TECHNICAL EVALUATION REPORT

MASONRY WALL DESIGN

ROCHESTER GAS AND ELECTRIC CORPORATION
R. E. GINNA NUCLEAR POWER PLANT

TER-C5506-262

Figure 3-6. Typical Modification

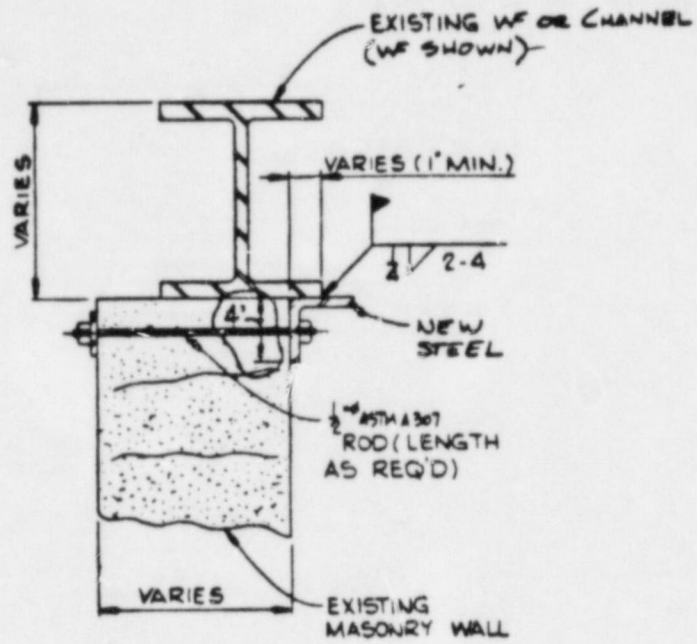
Modifications to the 29 panels that meet the SGEB criteria consisted of the addition of structural steel members at the edges to assure that the boundary conditions (pinned) are as assumed in the analysis (Figure 3-6). In some cases, intermediate supports were added across the face of the panel to reduce the panel span length.

The Licensee's approach to panel modifications has been reviewed and found adequate.
